## Morton Grove Park District Summary

The following comments are a summary of the Morton Grove Park District's accessibility survey. The survey was begun in the summer of 2013. Each park district facility and buildings used for programs were reviewed for their compliance with the new Americans with Disabilities Act Accessibility Guidelines (ADAAG), Illinois Accessibility Codes (IAC), and the proposed Outdoor Developed Standards. In addition, all elements were evaluated using Equivalent Facilitation standards (ADAAG 103) and Dimensional Tolerances (ADAAG 104.1.1).

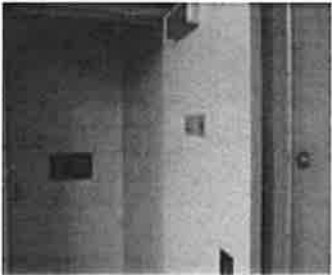
The men's restroom at the pavilion sink does not provide protective pipe wrap.	ADAAG 606.5	Provide a protective cover or protective pipe wrapping on the water shut offs and drain pipes.	3		\$ 75.00

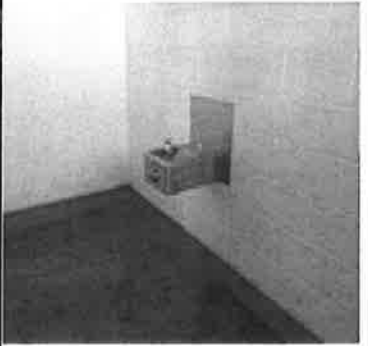
Photo	Barrier	ADAAG/IAC	Solution	Priority	By Whom	Projected Cost	Projecte d Date	Action Taken
	The women's locker room does not provide benches as the lockers.	ADAAG 222 & 903	Provide a bench that is a minimum 42" long, and a minimum of 20" to a maximum of 24" deep. The bench should be affixed to a wall or have a back support that extends at least 42" the length of the bench at a point a maximum of 2" above the seat. The accessible bench should be adjacent to the accessible lockers and have a seat between 17" to 19" AFF.	2		\$ 700.00		
	The women's locker room changing area seat is too high at 17 1/2" AFF.	ADAAG 222 & 903	Provide a bench that is a minimum 42" long, and a minimum of 20" to a maximum of 24" deep. The bench should be affixed to a wall or have a back support that extends at least 42" the length of the bench at a point a maximum of 2" above the seat. The accessible bench should be adjacent to the accessible lockers and have a seat between 17" to 19" AFF.	2		\$ 700.00

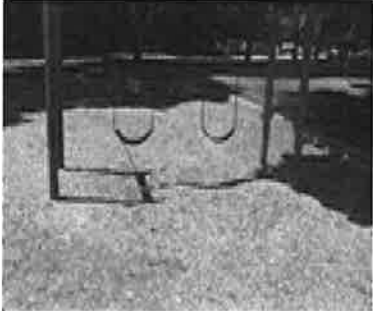
Photo	Barrier	ADAAG/IAC	Solution	Priority	By Whom	Projected Cost	Projected Date	Action Taken
	The walkway at the light post near the south playground has a gap of 3/4".	ADAAG 302.3	Fill in or replace section of sidewalk to provide a flush transition or an opening no greater than 1/2'.	1		\$ 280.00		
	The south walkway to the playground has a gap of 1" for 18'.	ADAAG 302.3	Fill in or replace section of sidewalk to provide a flush transition or an opening no greater than 1/2'.	1		\$ 840.00		
	The south walkway to the playground has branches that protrude between 63" to 79" AFF.	ADAAG 307	Trim the branch to provide an 80" minimum clear head space and back to the edge of the walkway.	1		\$ 50.00		
	There is a 5" drop off to the playground surface.	ADAAG 1008.2	Provide a curb ramp from the accessible walkway to the playground surface with a running slope no steeper than 8.3% and an cross slope no steeper than 2%.	2		\$ 1,225.00

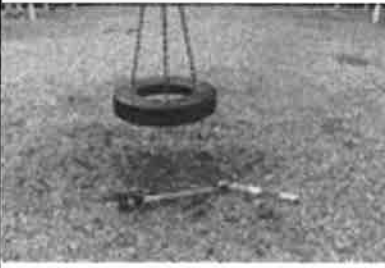
Photo	Barrier	ADAAG/IAC	Solution	Priority	By Whom	Projected Cost	Projected Date	Action Taken
	The south east entrance walkway has an abrupt transition of 1 1/4" at bricks.	ADAAG 303	Re-set the brick to provide a smooth transition.	<b>1</b>		\$ 360.00		
	The west playground entrance has a drop off of 1".	ADAAG 1008.2	Extend or provide a new curb ramp from the accessible walkway to the playground surface with a running slope no steeper than 8.3% and an cross slope no steeper than 2%. <b>Option:</b> Provide some additional playground surface material that eliminates the abrupt transition.	<b>2</b>		\$ 1,225.00		
	The playground transfer platform is mounted too high at 20" AFF.	ADAAG 1008.3.1.2	Regrade some engineered wood fiber to provide a transfer platform height between 11" AFF to 18" AFF. Provide a regular maintenance of this surface.	<b>2</b>		\$ 100.00		
	The sand digger is not located on an accessible route.	ADAAG 240.2 & ADAAG 1008.4.3	Consider one or two play components such as a sand digger, raised sand table, etc. that can be used from the accessible route up to the sand play area.	<b>2</b>		\$ 2,000.00

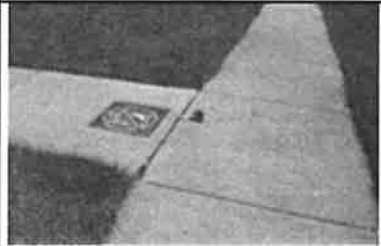
Photo	Barrier	ADAAG/IAC	Solution	Priority	By Whom	Projected Cost	Projected Date	Action Taken
	The sink counter is 34 3/4".	ADAAG 606	Remount the sink to provide a minimum 27" knee clearance and a rim height of no higher than 34" AFF.	<b>3</b>		\$ 1,850.00		
	The paper towel dispenser is mounted too high at 58 1/2" AFF.	ADAAG 308	Remount the paper towel dispenser to provide a reach range no higher than 48" AFF for a forward reach over an obstruction no deeper than 20" or a side reach of 48" AFF over an object no deeper than 10".	<b>3</b>		\$ 100.00		
	The women's restroom coat hook is mounted too high at 65" AFF.	ADAAG 308	Lower the existing coat hook or add a second coat hook at 48" AFF.	<b>4</b>		\$ 50.00		
	The exit doors have an opening force too high at 8 lbs. and close too quickly at 4 seconds.	IAC 400.310(j)(10) (B)(i)	Adjust the closer so the door opening force is no heavier than 8.5 lbs. to open and takes a minimum of 5 seconds to close or provide an automatic door opener at the door.	<b>1</b>		\$ 100.00

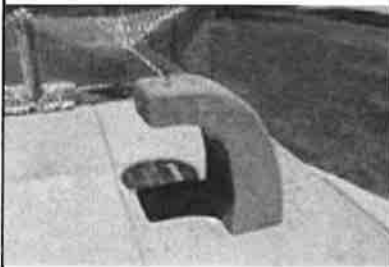
Photo	Barrier	ADAAG/IAC	Solution	Priority	By Whom	Projected Cost	Projected Date	Action Taken
	The tire swing surface slope is too high at 10.2% and too high at 27 1/4".	ADAAG 1008.4.2	Provide a regular maintenance to the play surface to provide an accessible route and cross slopes no greater than 2% in all directions for easier transfer to the swing. Provide swings no higher than 24" above the playground surface. An accessible swing with a seat would be recommended at some point. <b>UD</b> - Consider a mat under the swings to prevent a kick-out of the surface material.	2		\$ 100.00		
	The swing area has a 5" drop off and does not provide a curb ramp.	ADAAG 1008.2	Provide a curb ramp from the accessible walkway to the playground surface with a running slope no steeper than 8.3% and an cross slope no steeper than 2%.	2		\$ 1,225.00		
	The walkway at the picnic table has a gap of 3/4" for 16'.	ADAAG 302.3	Fill in or replace section of sidewalk to provide a flush transition or an opening no greater than 1/2'.	1		\$ 560.00

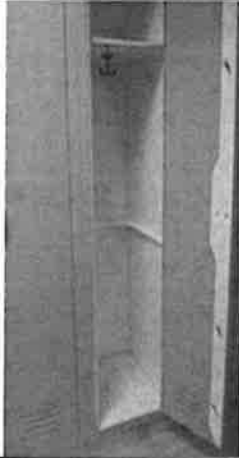
Photo	Barrier	ADAAG/IAC	Solution	Priority	By Whom	Projected Cost	Projected Date	Action Taken
	The directional signage is not of an accessible design.	ADAAG 216.3 & ADAAG 703.5	Provide a sign with a directional arrow that provides a contrast of color, at least 2" lettering and is mounted between 70" AFF to 120" AFF to the visual characters.	4		\$ 260.00		
	The women's locker room sink is mounted too high at 35" AFF to top.	ADAAG 606	Remount the sink to provide a minimum 27" knee clearance and a rim height of no higher than 34" AFF.	3		\$ 1,850.00		
	The women's locker room paper towel dispensers are mounted too high at 52 AFF.	ADAAG 308	Remount the paper towel dispenser to provide a reach range no higher than 48" AFF for a forward reach over an obstruction no deeper than 20" or a side reach of 48" AFF over an object no deeper than 10".	3		\$ 100.00

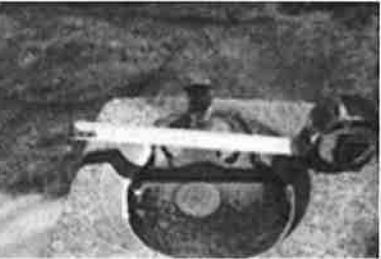
Photo	Barrier	ADAAG/IAC	Solution	Priority	By Whom	Projected Cost	Projected Date	Action Taken
	The walkway at the entrance to the park has branches that protrude 68" - 79" AFF.	ADAAG 307	Trim the branch to provide an 80" minimum clear head space and back to the edge of the walkway.	<b>1</b>		\$ 50.00
